RE: Town of Brookhaven Sewer District #2
Proposed Installation of Leaching Pool for
Compliance with SCDPW Requirements
Compatible Growth Area Hardship Waiver Application
Yaphank, Town of Brookhaven
SCTM Numbers 200-554-3-4.40 and 4.53

This letter provides responses and information to the request for additional information as outlined on page 6 of the public hearing package and your February 21, 2025, email regarding supplemental information.

Figure 3 – National Wetlands Inventory Layer.

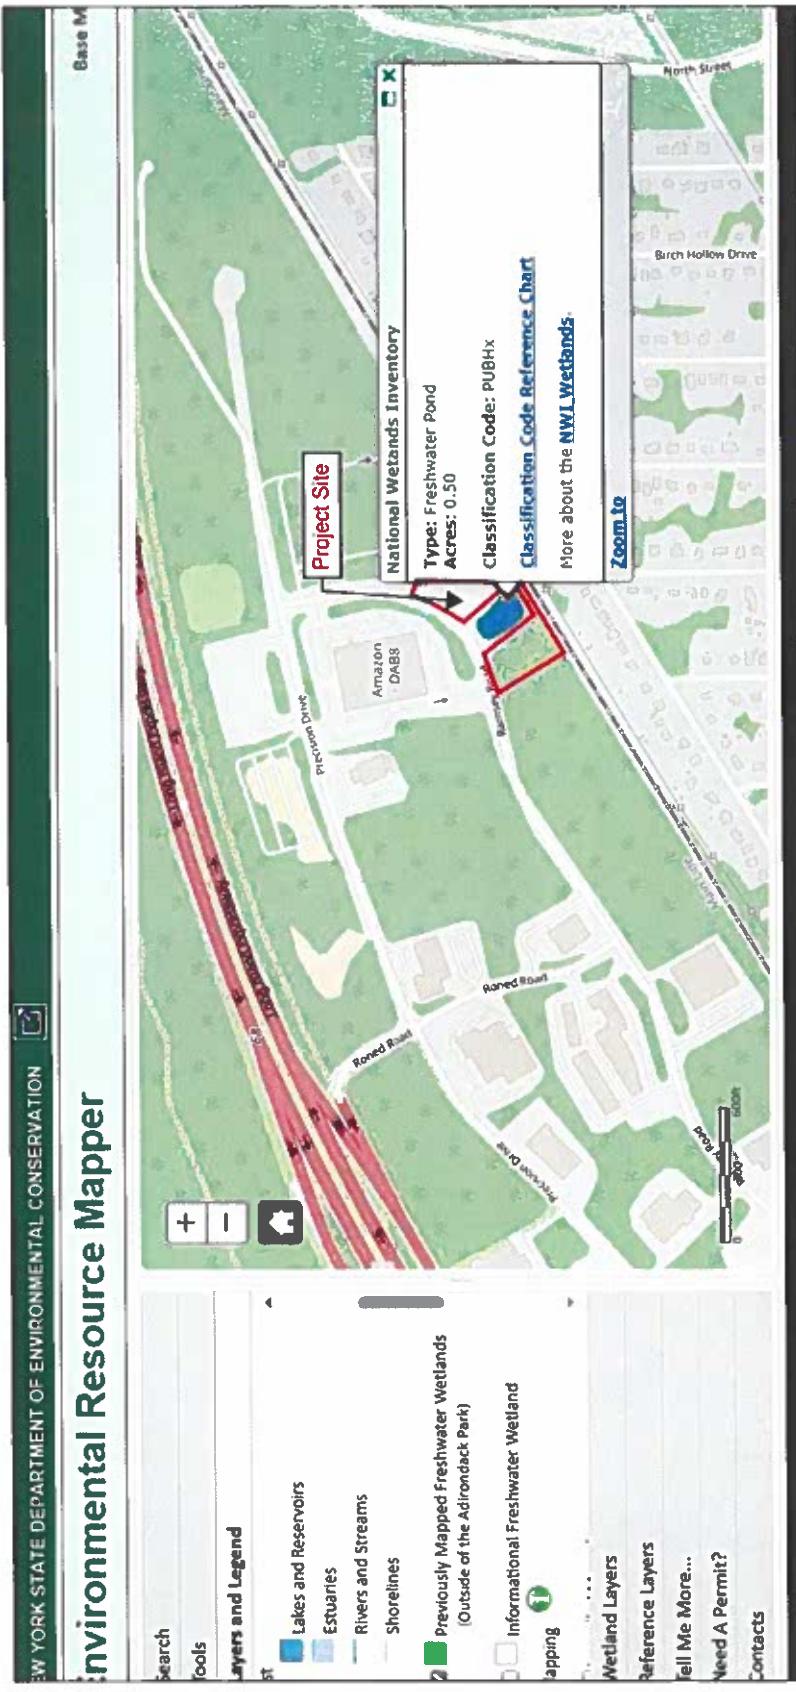
3. The Applicant must identify the federal wetlands present on the Project Site that are indicated on Part 1 of the submitted EAF and address related protections during and after construction. No NYSDEC mapped and regulated wetlands appear to be present.

Response: *The EAF was generated using the NYS DEC (DEC) EAF Mapping Tool. The federal wetlands as identified on Part 1 of the EAF is in error. The location is in fact a recharge basin situated next to the treatment plant.*

The two figures on the next page show the recharge basin next to the treatment plant without, and with NWI layer. Figure 2 shows the DEC's freshwater wetlands (shown as green polygon) and tidal wetlands layer turned on and the recharge basin was not identified as a wetland. Figure 3 shows the addition of the NWI layer which identified the recharge basin next to the treatment plant as well as two other nearby basins as a freshwater pond (blue polygon). And Figure 4 shows the location of the three recharge basins (marked by layer) along with photo of the entrance gate to the basins.

Based on in-depth review of the information by NWI, it is determined that the recharge basin as identified in Part 1 of the EAF is incorrectly labelled as "federal wetlands" by NWI.

The recharge basin is identified by NWI as Freshwater Pond with classified code of PUBHx and the letter "x" is a special modifier which stands for excavated to identify wetland basins or channels that were excavated by humans.

Figure 5 – Phase Map.

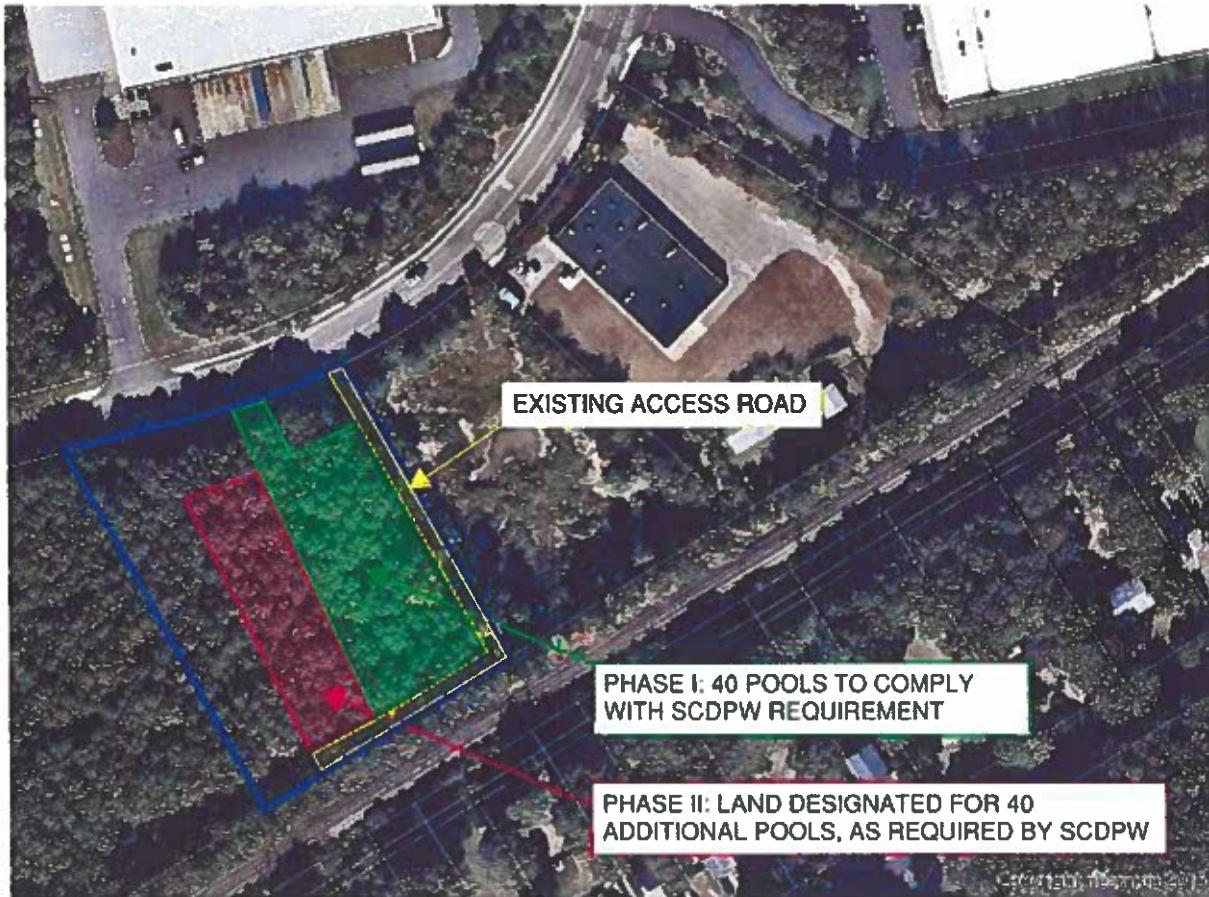
9. The Applicant should consider establishing phased development areas for (1) the 40 leaching pools proposed to satisfy the current 80-leaching pool requirement and (2) the future 40 leaching pools to meet the 120-leaching pool expansion requirement. If so, the Applicant should delineate the areas and retain the natural vegetation in the Phase 2 development area until the final cluster of leaching pools are to be installed.

Response: *Town of Brookhaven has considered the phased approach and has revised the clearing limit to show Phase 1 (the required set of 40 pools) and phase 2 future replacement/expansion area. This is shown in Figure 5 below.*
